Access Compliance Report

Public Rights-of-Way

(Pedestrian Signals)

Intersection ID: N/A	Main Street:	Cross Street: N/A	Location: N/A
ADA ID: 013B9D0E1A9C	Signal Type: Two Push Buttons-APS	Overall Compliance: No	Severity Score: BTN 1:N/A BTN 2: N/A No BTN: N/A
Codes/Mitigation Info/Possible Solution		Field Measurements/Component Compliance

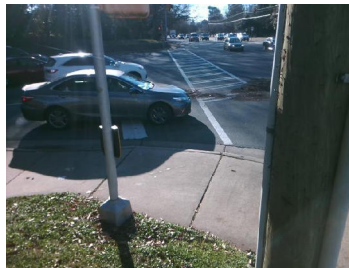
Compliance	Description	Data	Compliance	Description	Data
	Button Count	Button2	N/A	Distant to Additional Button (in)	N/A
	Additional Button Present?	No		Additional Button ID	N/A
N/A	Signal Buttons Required?	N/A	N/A	Additional Ped Posts Required	N/A
	How Many Ped Street Xings?	2		Located In An Island/Median?	No
N/A	B 1 Sign Present?	Yes	N/A	B 2 Sign Present?	Yes
Yes	B 1 Sign Purpose?	Yes	Yes	B 2 Sign Purpose?	Yes
Yes	B 1 Sign Lettering & Contrast?	Yes	Yes	B 2 Sign Lettering & Contrast?	Yes
Yes	B 1 Parallel To XWalk?	Yes	Yes	B 2 Parallel To XWalk?	Yes
Yes	B 1 PAR to Button?	Yes	Yes	B 2 PAR to Button?	Yes
Yes	B 1 PAR to XWalk?	Yes	Yes	B 2 PAR to XWalk?	Yes
Yes	B 1 Clear Floor Space?	Yes	Yes	B 2 Clear Floor Space?	Yes
N/A	B 1 FWD Approach?	Yes	N/A	B 2 FWD Approach?	Yes
N/A	B 1 FWD Approach Constrained?	No	N/A	B 2 FWD Approach Constrained?	No
No	B 1 FWD Approach Reach (in)	14.0	No	B 2 FWD Approach Reach (in)	8.0

N/A	B 1 FWD Approach Width (in)	N/A	N/A	B 2 FWD Approach Width (in)	N/A
N/A	B 1 FWD Approach Obstruction?	Yes	N/A	B 2 FWD Approach Obstruction?	Yes
N/A	B 1 FWD Approach Obstruction Dist (in)	6.0	N/A	B 2 FWD Approach ObstructionDist (in)	3.0
N/A	B 1 PARA Approach?	Yes	N/A	B 2 PARA Approach?	Yes
N/A	B 1 PARA Approach Constrained?	No	N/A	B 2 PARA Approach Constrained?	No
Yes	B 1 PARA Approach Reach (in)	6.0	Yes	B 2 PARA Approach Reach (in)	5.0
N/A	B 1 PARA Approach Width (in)	N/A	N/A	B 2 PARA Approach Width (in)	N/A
N/A	B 1 PARA Approach Obstruction?	Yes	N/A	B 2 PARA Approach Obstruction?	Yes
N/A	B 1 PARA Approach Obstruction Dist (in)	3.0	N/A	B 2 PARA Approach ObstructionDist (in)	2.0
Yes	B 1 Clear Floor Space Slope (%)	1.4	Yes	B 2 Clear Floor Space Slope (%)	1.6
Yes	B 1 Clear Floor Space XSlope (%)	0.9	Yes	B 2 Clear Floor Space XSlope (%)	1.2
N/A	B 1 PAR Slope (%)	0.3	N/A	B 2 PAR Slope (%)	2.7
Yes	B 1 Height (in)	43.0	Yes	B 2 Height (in)	42.0

Yes B 1 Clear Xing Direction?	ClearlyMarked	Yes B 2 Clear Xing Direction?	ClearlyMarked
B 1 Crossing Direction	To SW	B 2 Crossing Direction	To SE
No B 1 DistanceTo XWalk (in)	106.0	No B 2 DistanceTo XWalk (in)	87.0
No B 1 DistanceTo Curb (in)	130.0	No B 2 DistanceTo Curb (in)	103.0
Yes B 1 Diameter (in)	2.0	Yes B 2 Diameter (in)	2.0

Possible Solutions: Replace Signal Push Button With APS Button on New Post. Remove & Relocate Sign.
